SERVICE BULLETIN

No. 766

Piper Aircraft Corporation

Main Landing Gear Slotted Uplock Hook
Brackets Replacement

SKETCH "A"

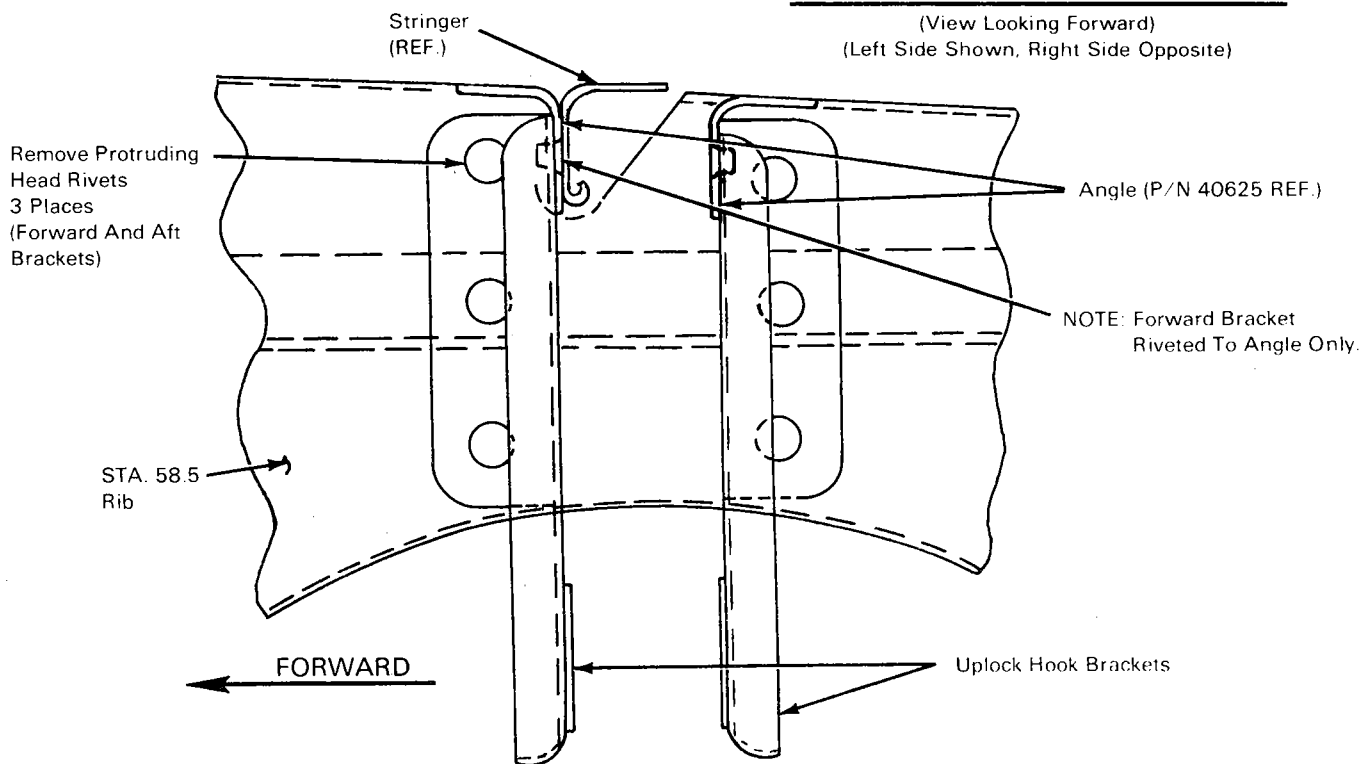
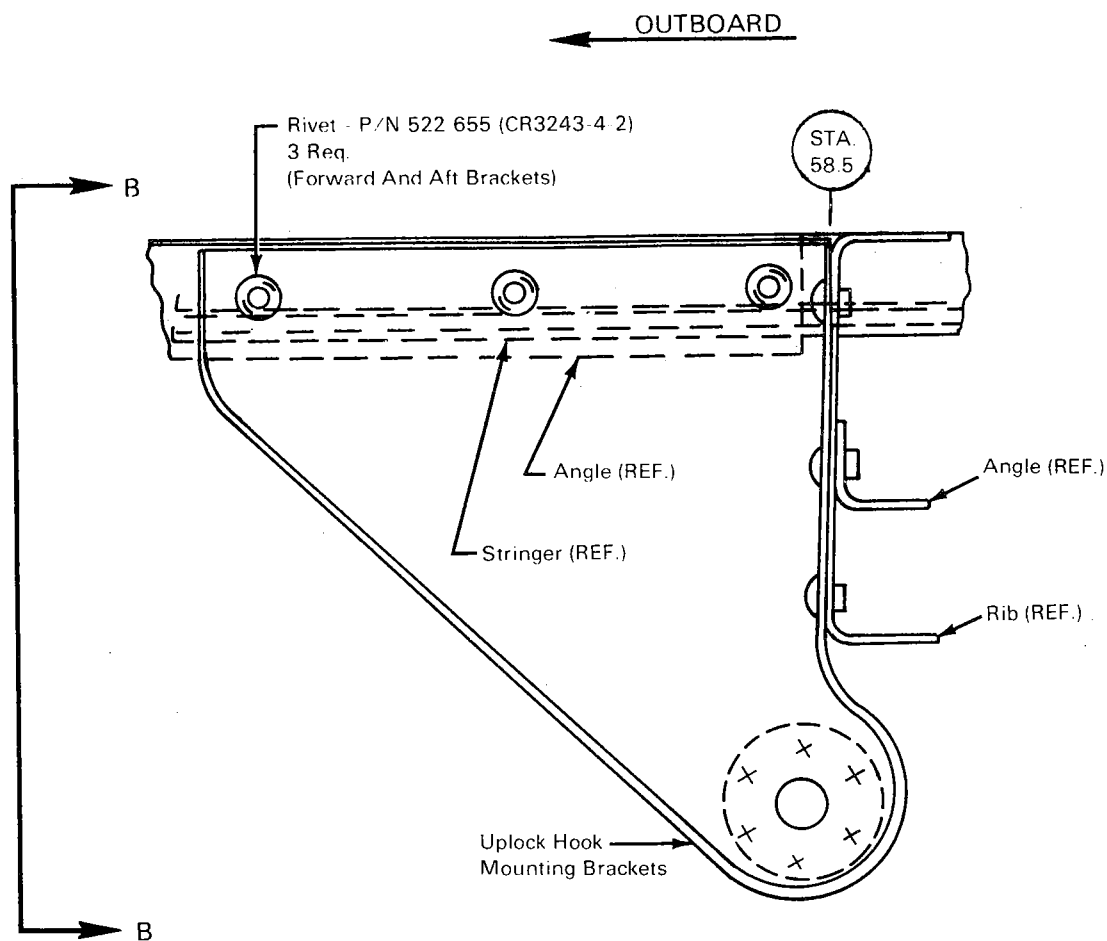
1. With the master switch off select gear down then actuate the hydraulic
handpump to open the main landing gear inboard doors. To facilitate
reinstallation, take note as to how the spacer bushings are used in the
connection of the uplock hook actuating rods to their uplock hooks.
2. Disconnect the rods from the uplock hooks, and disconnect the Emergency
Gear Extension Actuator Pushrods.
3. Remove the bolts securing the uplock hooks to their brackets.
4. To aid in the removal of the brackets, disconnect the Emergency Gear
Extension Uplock Hook Actuators from their mounts and move them out of
the way.
5. Using an angle drill, drill out the rivets mounting the brackets, to the
wing structure (See Sketch A).

Each of the forward most uplock hook brackets is riveted to the
40625 angle only. These rivets must be drilled out from the
bucked end. Once the bucked ends have been removed, flex the
40625 angle outward with a screwdriver to remove the heads of
the flush rivets. (Refer to Sketch A).

SKETCH "B"

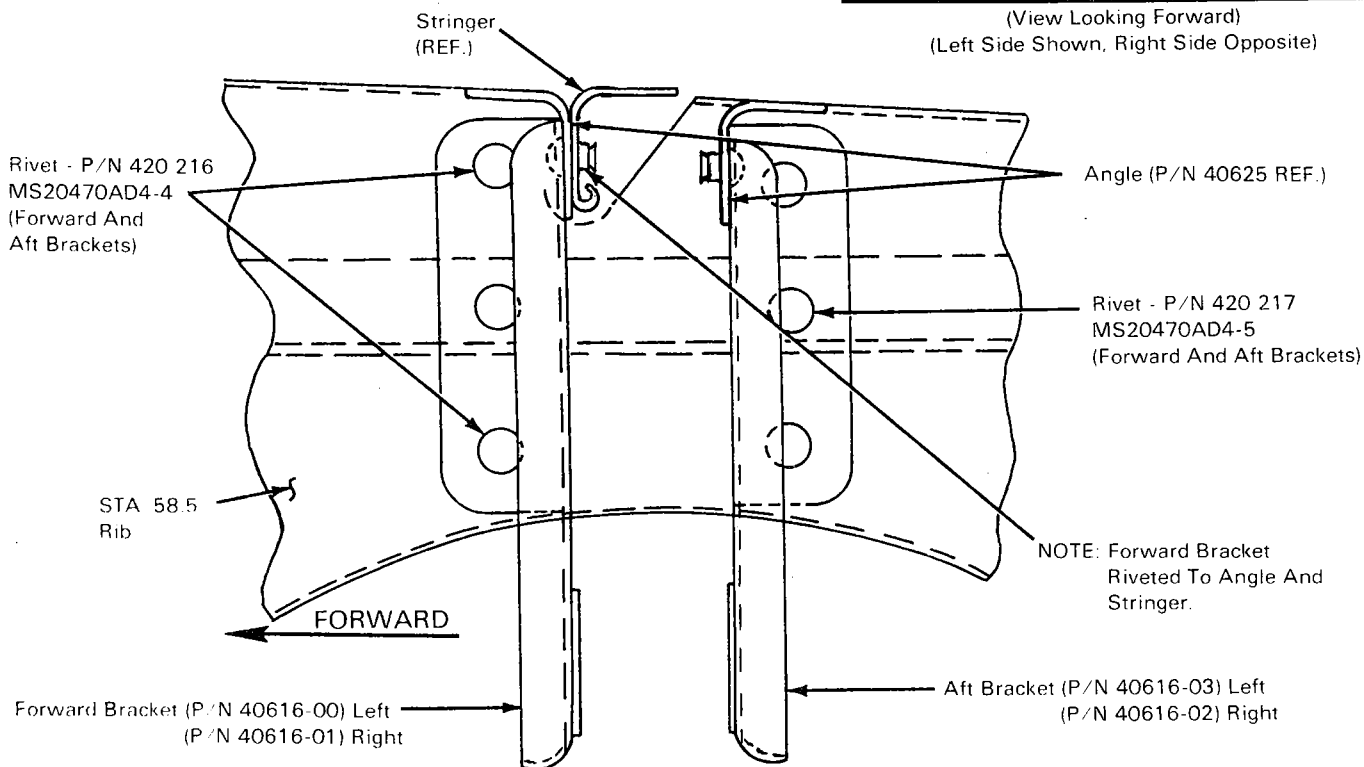
6. Install the 40616-00, Forward Left; 40616-03, Aft Left; 40616-01, Forward Right; and 40616-02, Aft Right Uplock Hook Brackets as shown in Sketch B using the rivets specified.
7. Install the uplock hooks and their springs, and reconnect the actuating rods.
8. Reinstall the Emergency Gear Extension Uplock Hook Actuators and reconnect their push rods.
9. Place the airplane on jacks and perform a retraction test to assure the system is working properly. Adjust as necessary, refer to Service Manual Section VII.
10. Make appropriate logbook entry of compliance with this Service Bulletin.
